#### SUFFOLK COUNTY PLANNING COMMISSION

## STAFF REPORT SECTIONS A14-14 THRU A14-25 OF THE SUFFOLK COUNTY ADMINISTRATIVE CODE

**Applicant:** Proposed "Extension of Chapter 17 J, Moratorium on Lawrence Aviation

**Applicant:** NMF/IAAI@Yaphank

Z-2: NMF/IAAI @ Yaphank SCPD: BR-09-28.3 SCTM No: 0200-739.00-03.00-001.000

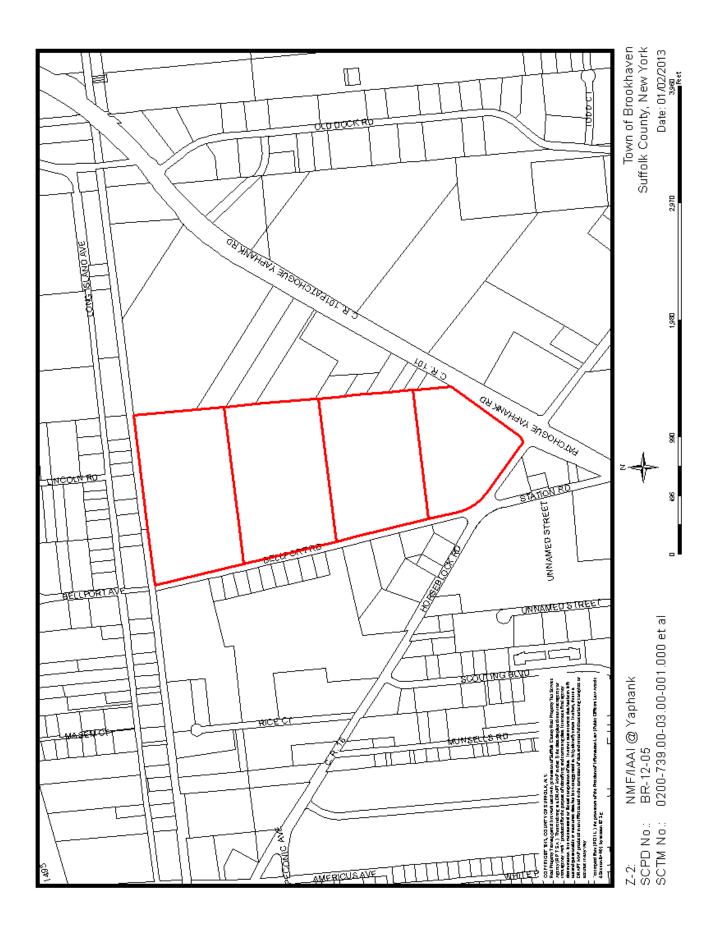
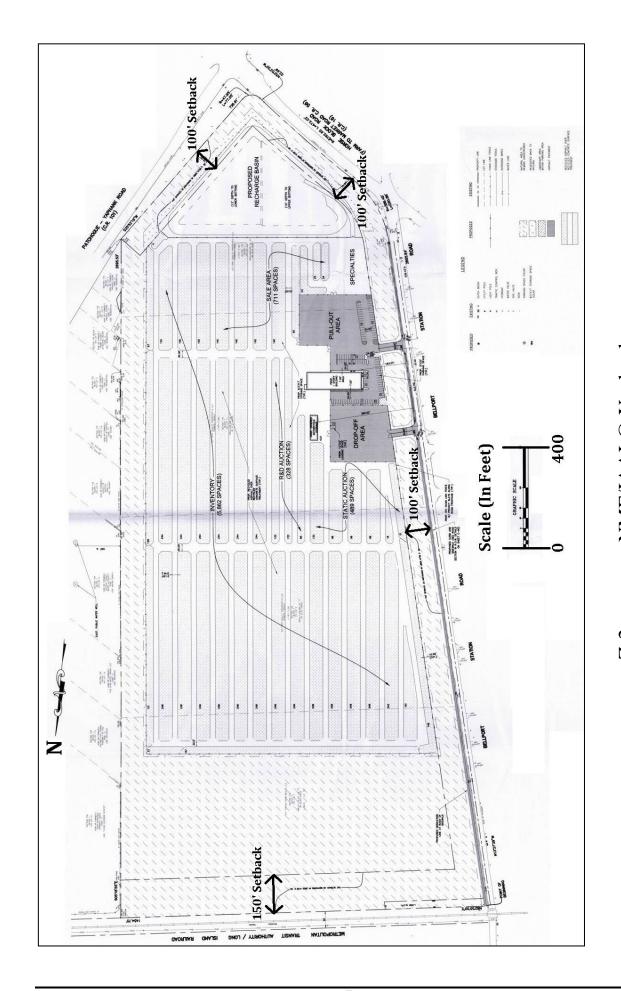
1. The applicant should review the Suffolk County Planning Commission publication entitled Managing Stormwater-Natural Vegetation and Green Methodologies.

The Suffolk County Planning Commission guidebook recommends the promotion of the use of green methodologies such as rain gardens and bioswales to control on site stormwater runoff. Methods should be incorporated throughout the proposed development to lessen the on-site contributions to the proposed recharge basin and thereby clarify the need for the basin.

2. Dialogue should continue with the Suffolk County Department of Public Works as is necessary for permits and approvals.

There appears to be a recorded 100' setback along the county R.O.W's (Liber 4739 P. 59) as indicated on the referred Conceptual Site Layout Plan. The location of the proposed recharge basin should be reviewed with the SCDPW in order to ensure that it does not alter or encroach on any existing plans for the County Road system in this area. As indicated above, the applicant and the Department of Public Works should discuss Green Methodologies for the control of storm water runoff in this area and validate the necessity of the recharge basin.

3. Dialogue should continue as is necessary for permits and approvals with the Suffolk County Department of Health Services.

A public water supply well field and elevated water storage tank facility, operated by the Suffolk County Water Authority is located on an adjacent parcel to the east of the proposed Auto Auction Yard. The location of the public water supply well field to the east should be noted and any potential adverse impacts from the storage of motor vehicles to the zone of capture for the water supply should be mitigated to the maximum extent practicable.
